Access Compliance Report

Public Rights-of-Way

(Curb Ramps)

Intersection ID: 15287	Main Street: ALBEMARLE_RD	Cross Street: N_SHARON_AMITY_RD	Location: SW
ADA ID: D689B285E2B1	Ramp Type: Para	Initial Pass/Fail: Fail	Overall Compliance: No
			Severity Score: 13.75

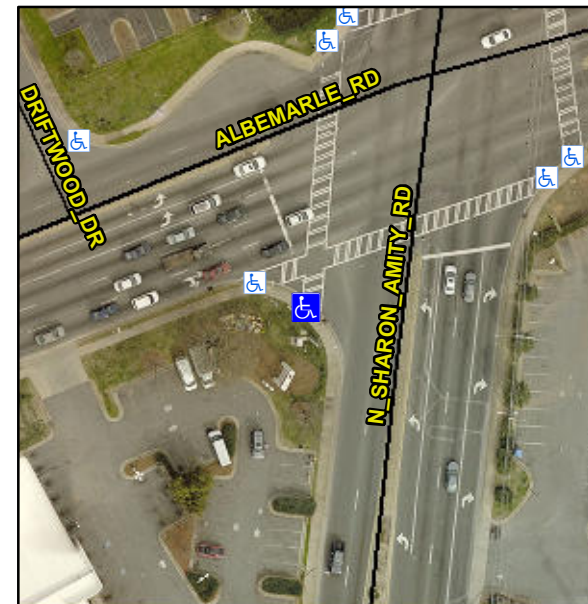
Surveyor Notes:

RT RP < 5%

PROW/ADA:

R304.3.2, R304.5.3

Compliance	Description	Data	Compliance	Description	Data
N/A	Ramp Length LT (in)	65.5	N/A	Ramp Length RT (in)	57.5
Yes	Ramp Width LT (in)	65.0	Yes	Ramp Width RT (in)	65.5
No	Ramp Slope LT (%)	10.9	Yes	Ramp Slope RT (%)	1.9
No	Ramp XSlope LT (%)	3.6	No	Ramp XSlope RT (%)	3.9
N/A	Landing Length (in)	N/A	N/A	DWS Provided?	N/A
N/A	Landing Width (in)	N/A	N/A	DWS Contrast?	N/A
N/A	Landing Slope (%)	N/A	N/A	DWS Length (in)	N/A
N/A	Landing X Slope (%)	N/A	N/A	DWS Full Width?	N/A
N/A	Landing Curb? (Y/N)	N/A	N/A	DWS Offset (in)	N/A
N/A	Shared Landing?	N/A			
N/A	Gutter Ponding?	N/A	N/A	Gutter Slope (%)	N/A
N/A	Gutter Lip Ht (in)	N/A	N/A	Gutter X Slope (%)	N/A
N/A	Painted X Walk1?	Yes	N/A	Painted X Walk2?	N/A
	X Walk 1 Direction	To N		X Walk 2 Direction	N/A
N/A	X Walk 1 Width (in)	110.0	N/A	X Walk 2 Width (in)	N/A
	X Walk 1 Slope (%)	4.3		X Walk 2 Slope (%)	N/A
	X Walk 1 X Slope (%)	2.6		X Walk 2 X Slope (%)	N/A
N/A	Ramp inside XWalk1?	Yes	N/A	Ramp inside XWalk2?	N/A

Possible Solutions:

Remove & Replace Entire Ramp.
